**AGENDA
HISTORIC DISTRICT COUNCIL
REGULAR MEETING (VIRTUAL)
JULY 16, 2020
5:00 PM
CITY HALL COMMISSION CHAMBERS
204 ASH STREET
FERNANDINA BEACH, FL 32034**

- 4.2 HDCA 2020-0016: GEORGE MOELLER, 416 N. 3RD STREET**
Amending COA 2018-16 - Changing rear gable siding, modifying a window opening, and replacing foundation infill design. *(Quasi-Judicial)*

MOELLER RESIDENCE
416 N. 3RD STREET
FERNANDINA BEACH
NASSAU COUNTY, FLORIDA

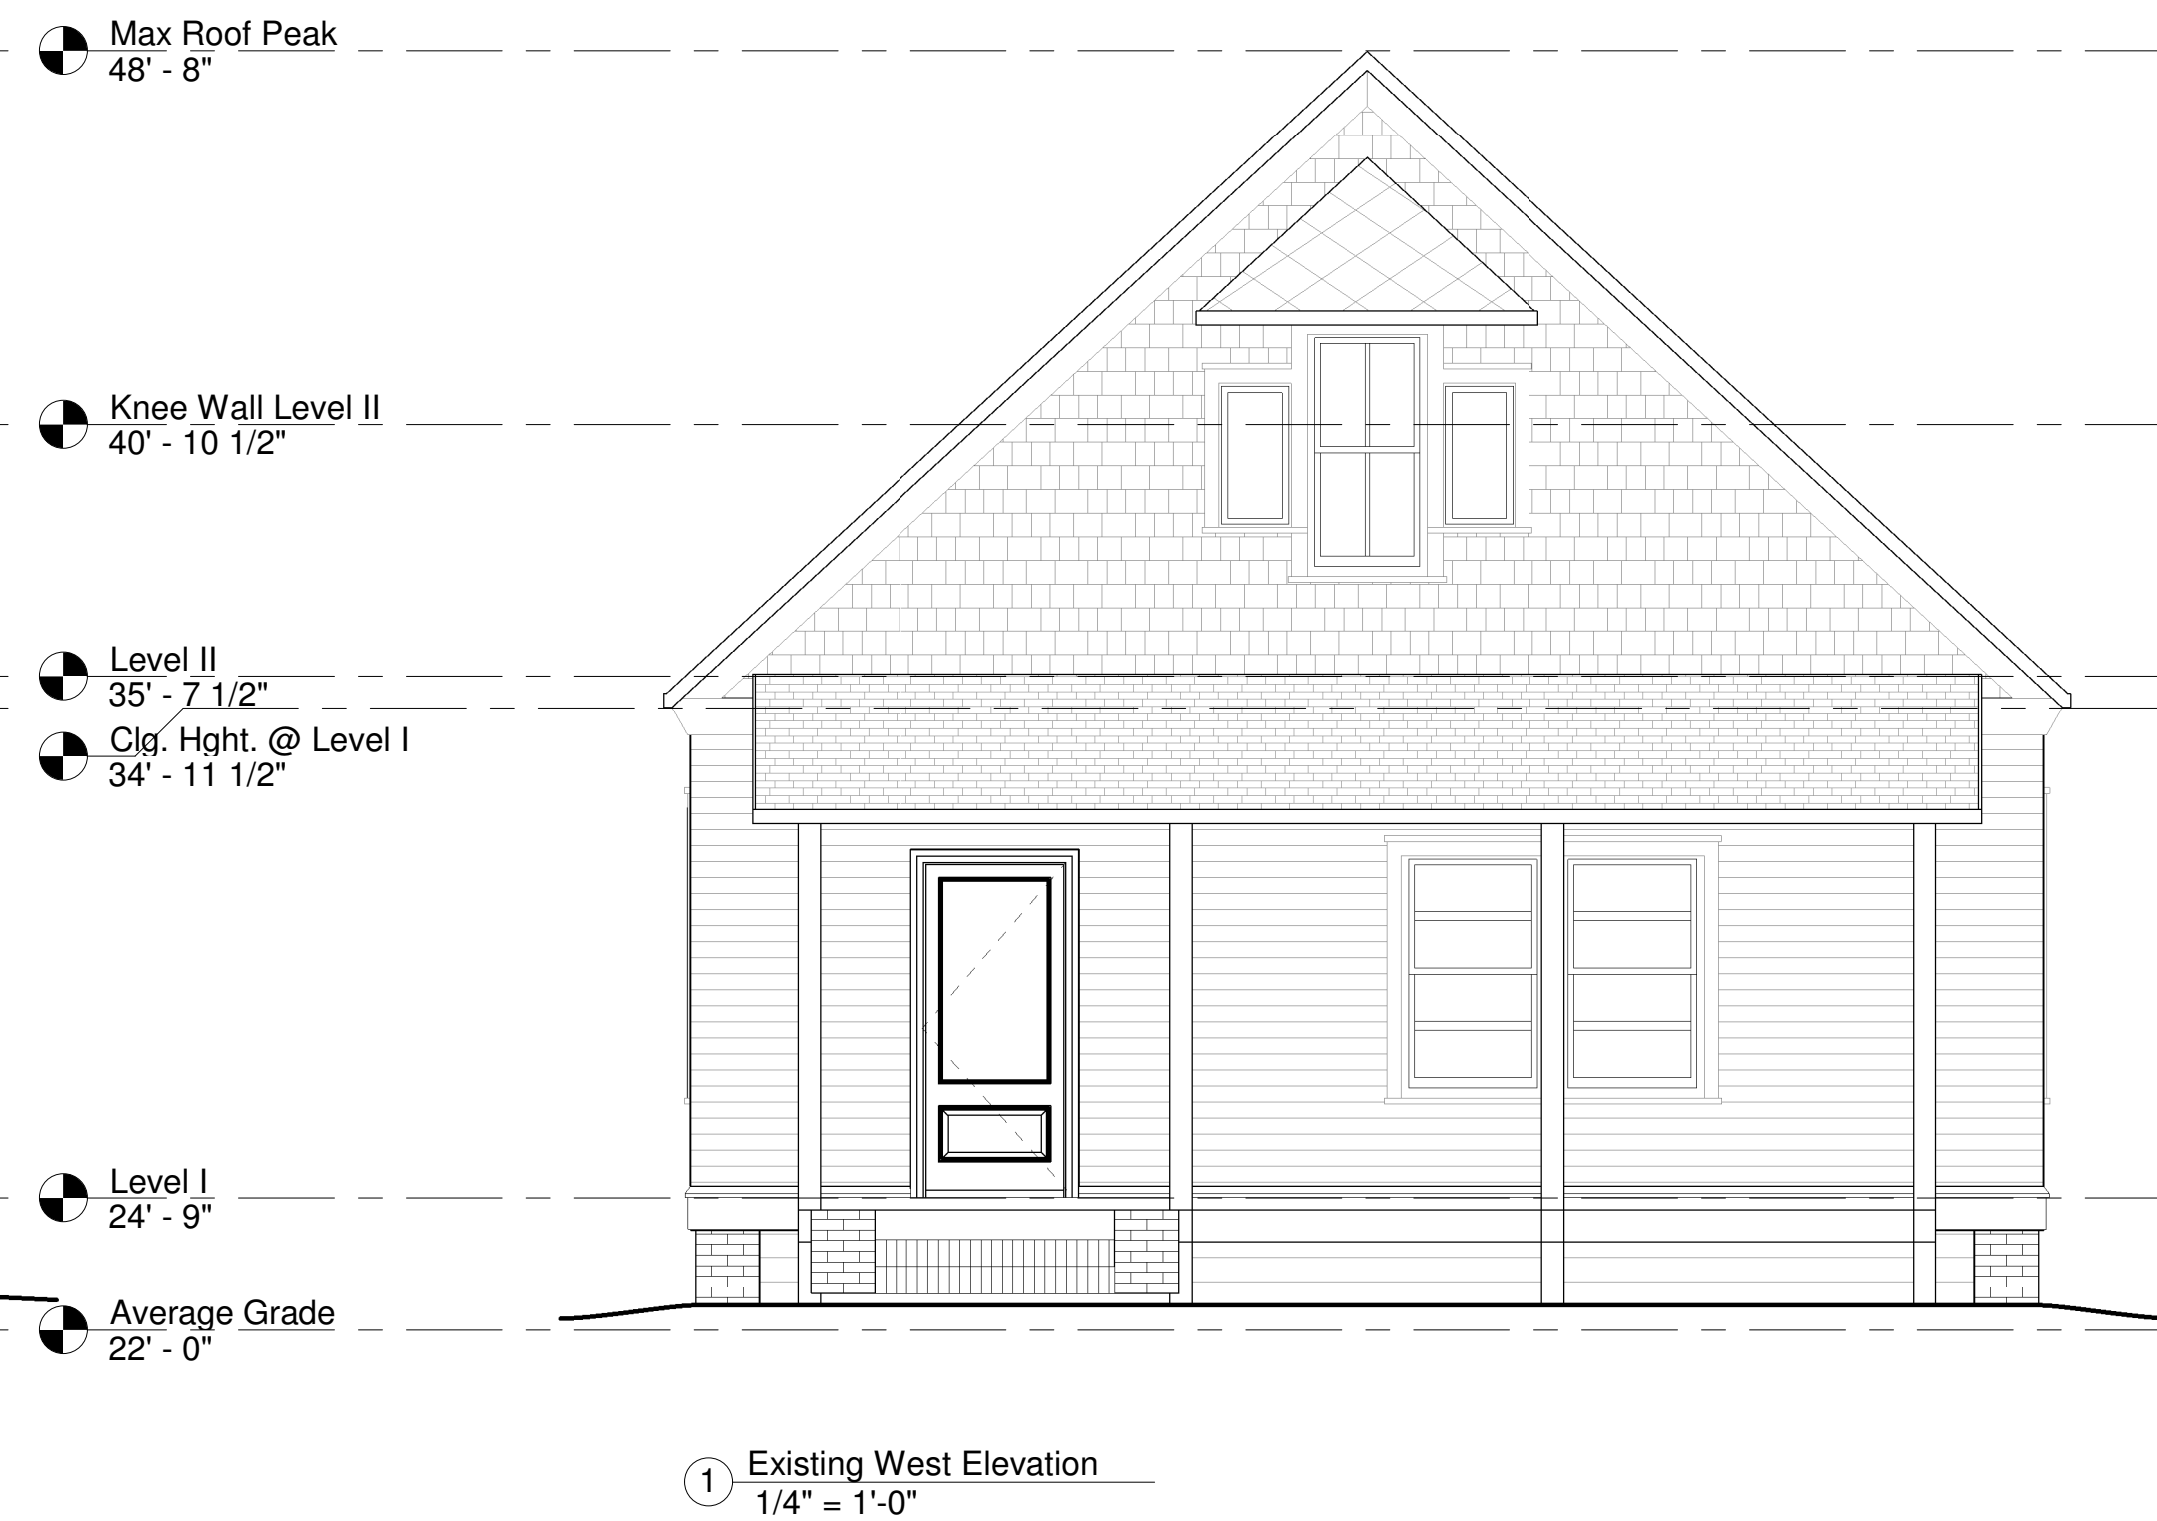
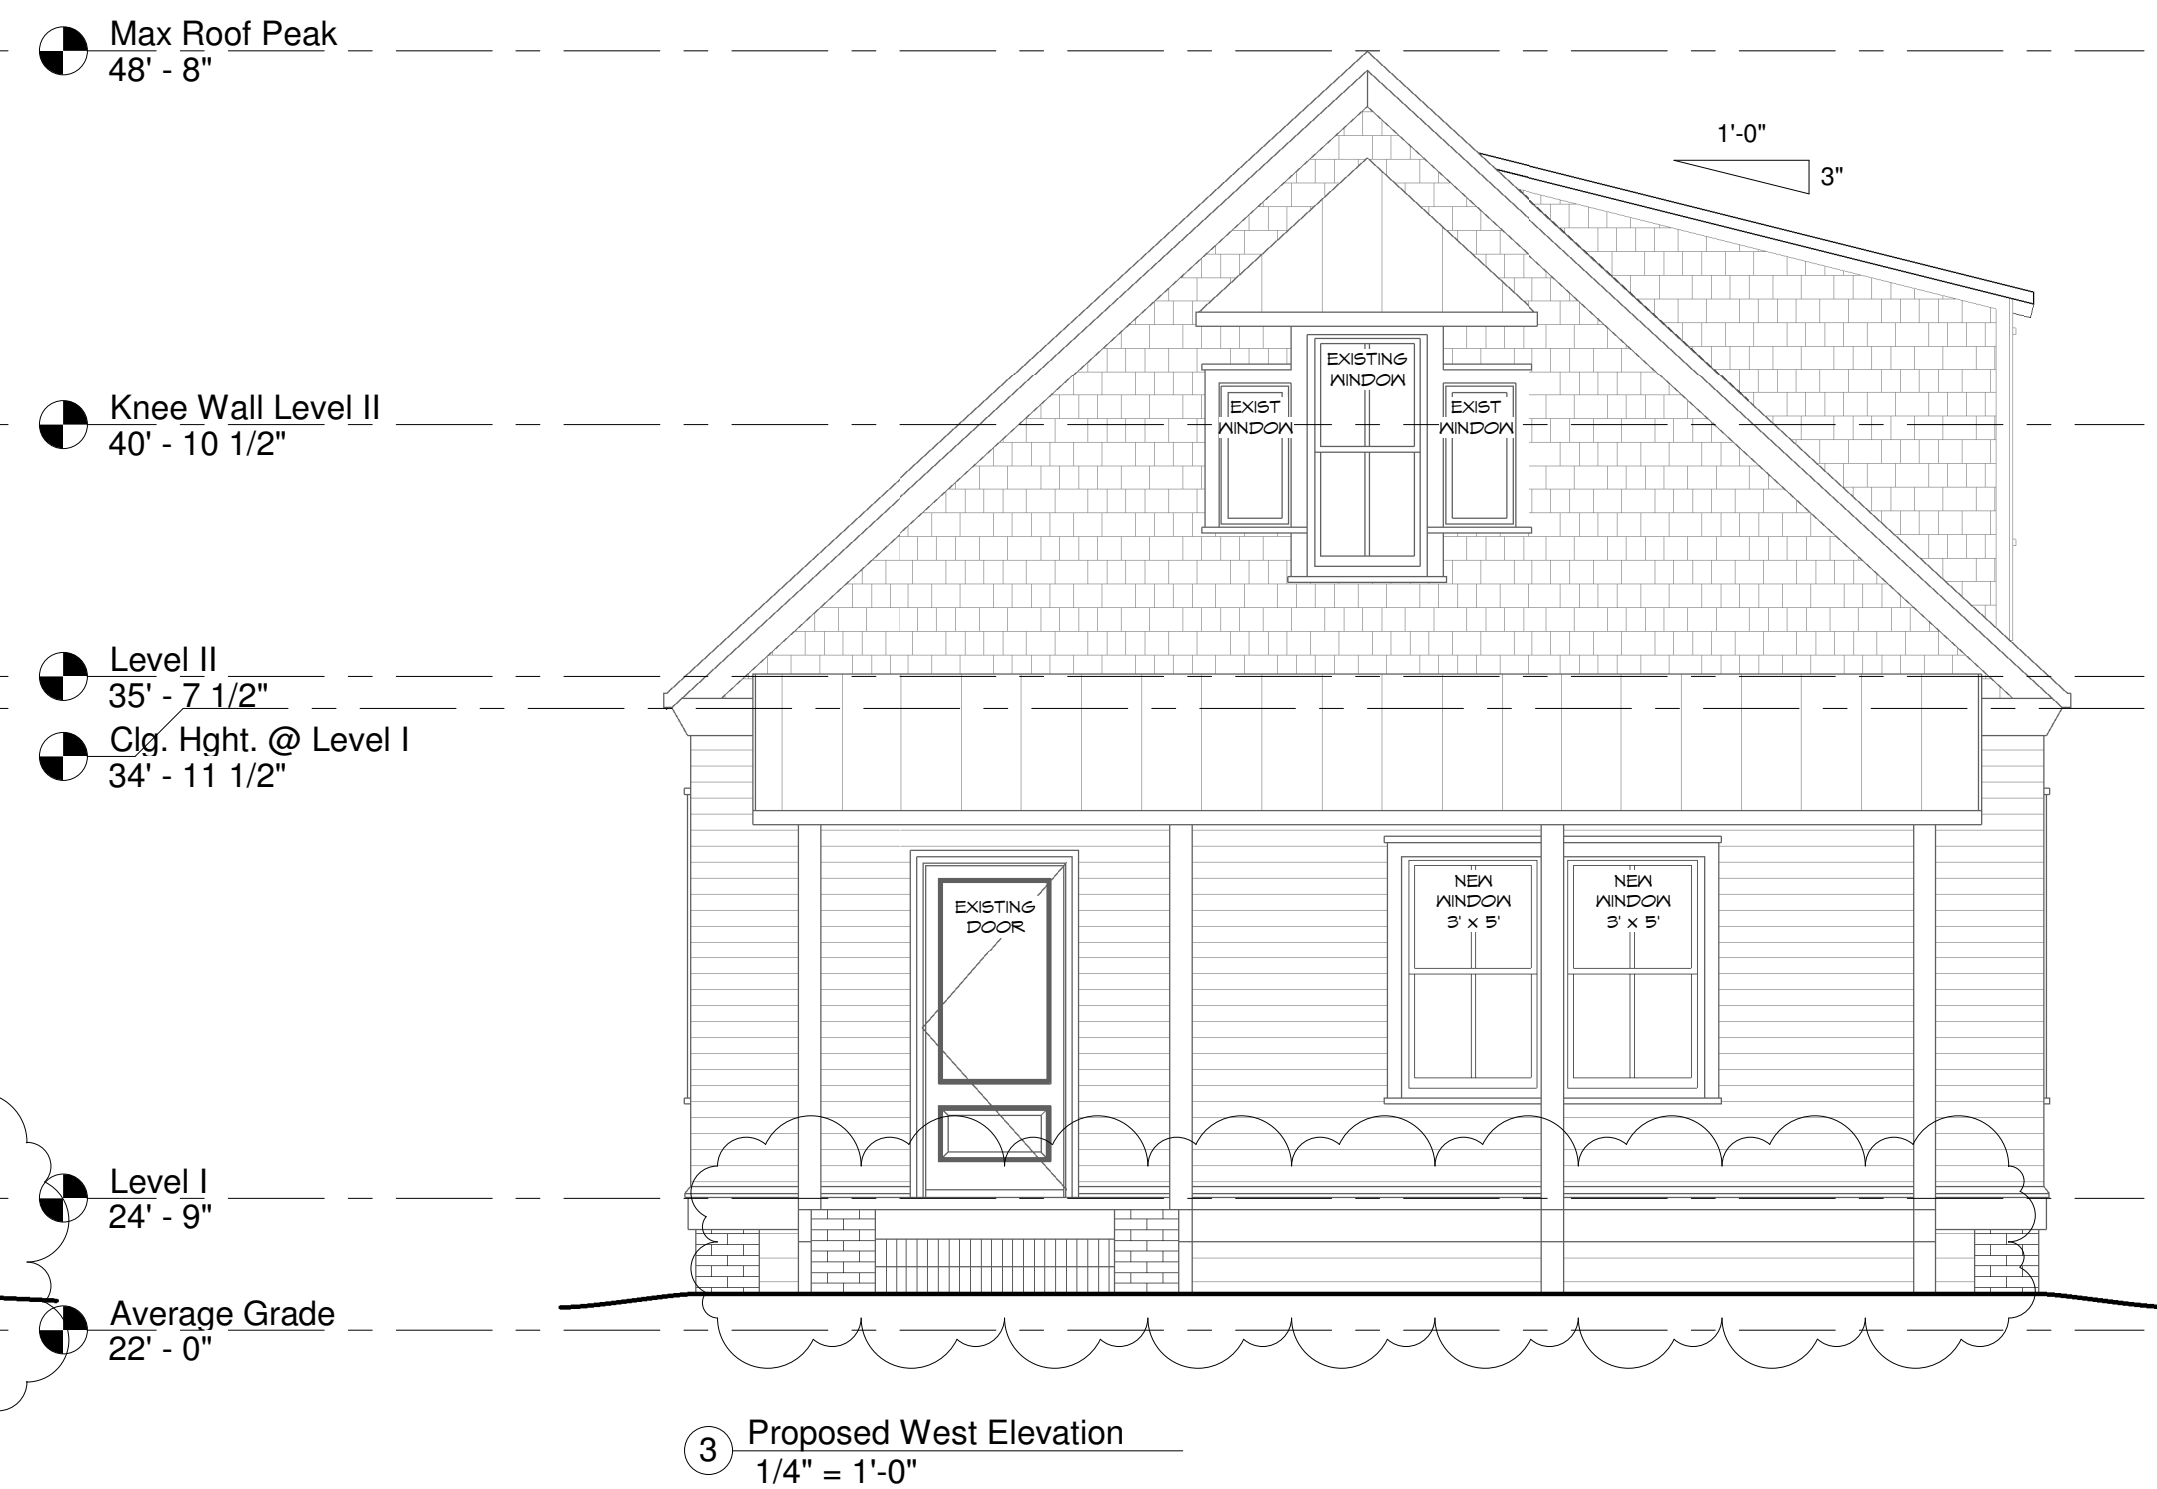
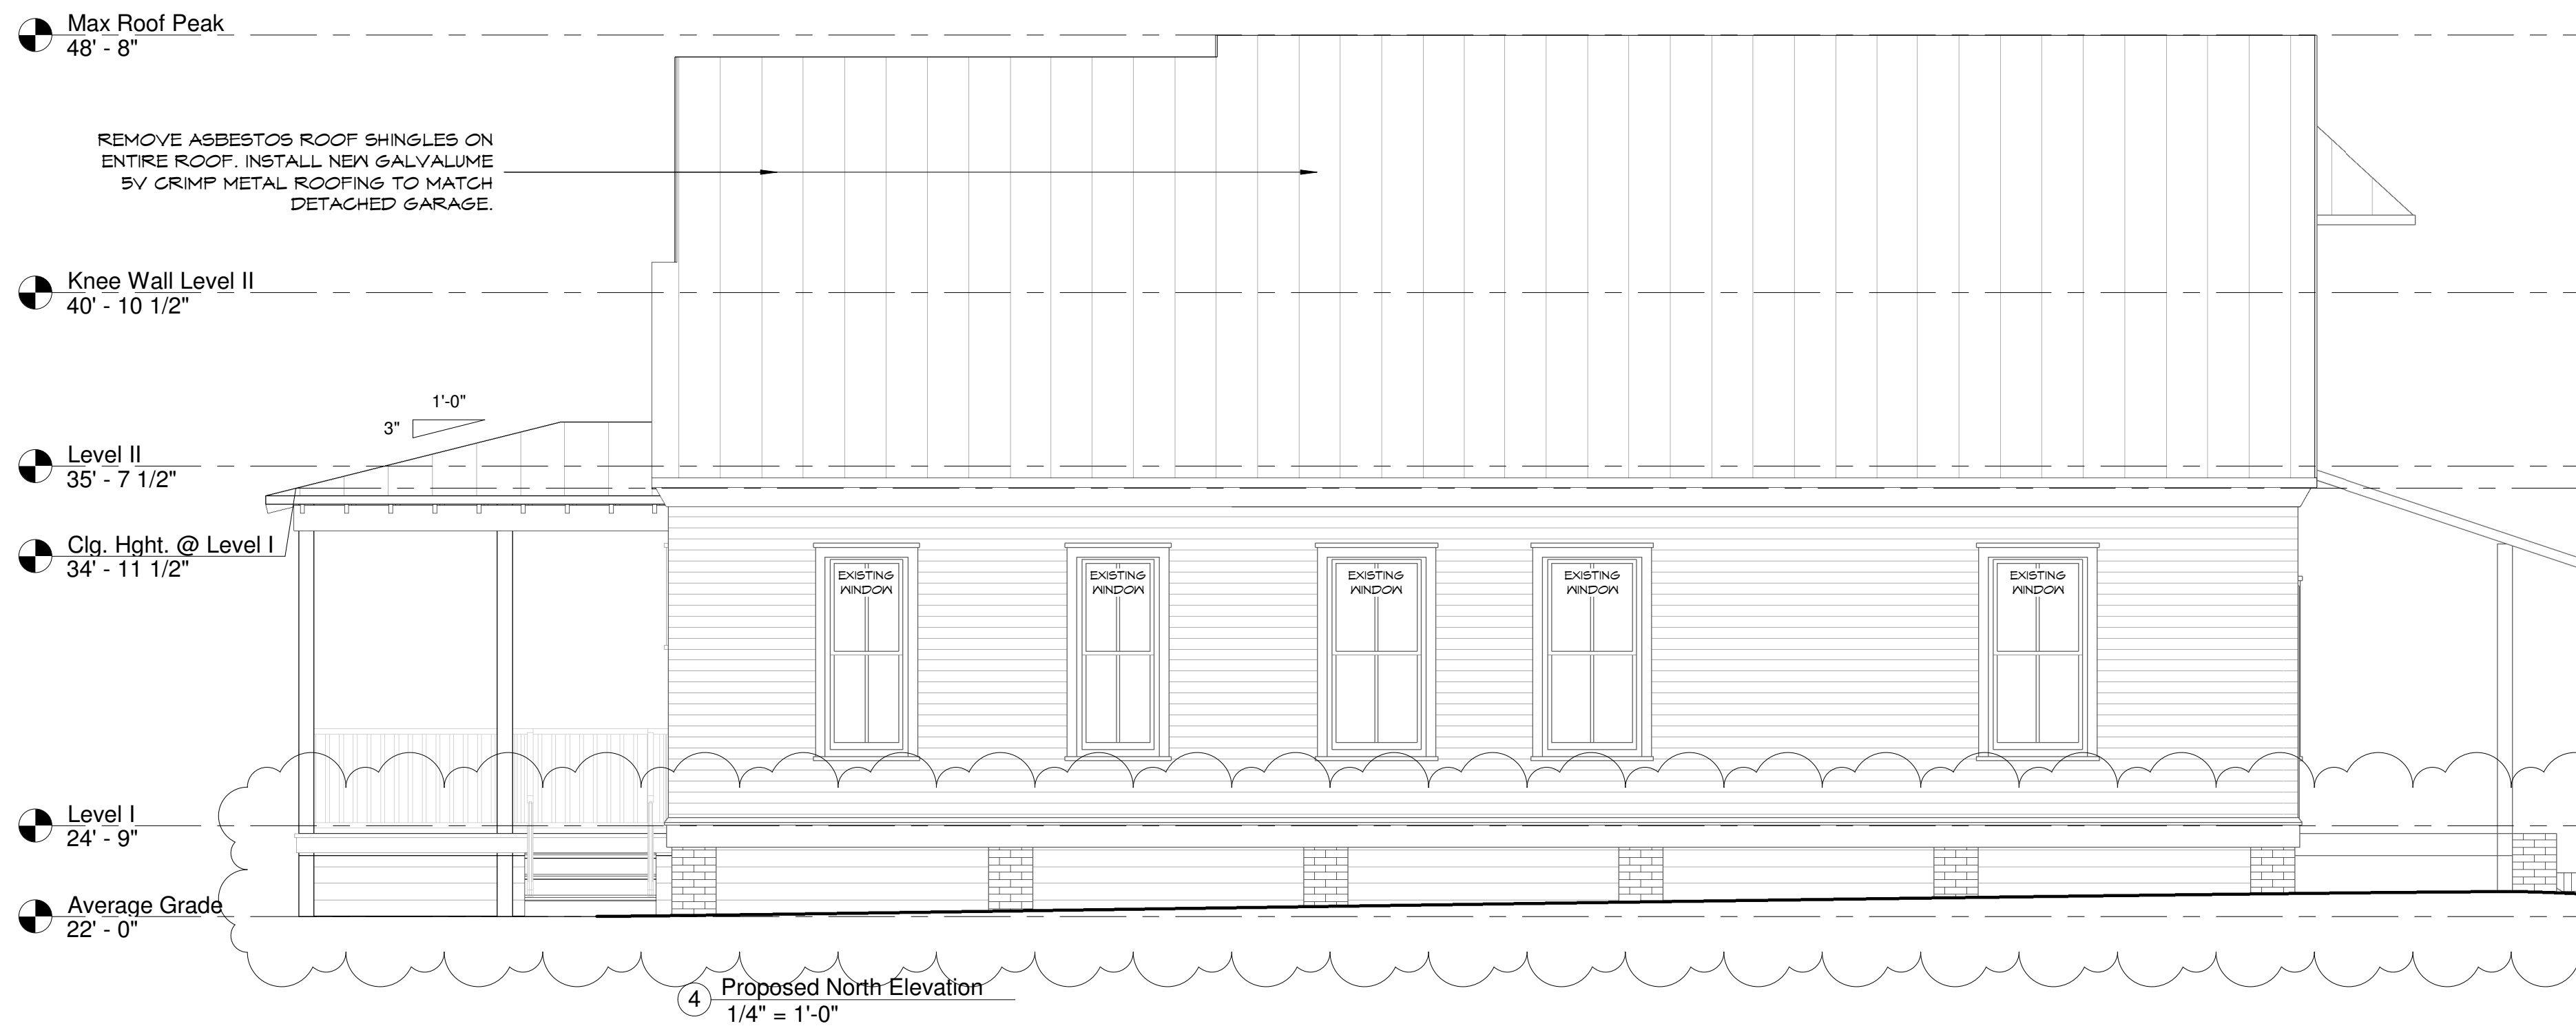
The applicant has made changes to the rear gable siding, lattice design, and modified a window opening. The applicant has requested that we approve the Historic District inspection associated with the building permit absent of paint. Staff ask the board to provide direction as to the acceptable length of time to allow the applicant to finish painting the exterior of the structure.

The change in gable siding material is consistent with the contributing structure's Frame Vernacular style. The change in window openings is on the rear addition approved with COA 2018-26. Downtown Design Guidelines encourage the use of lattice panels between pier foundations. However, the wood skirting that has been added maintains the visibility of the pier foundation.
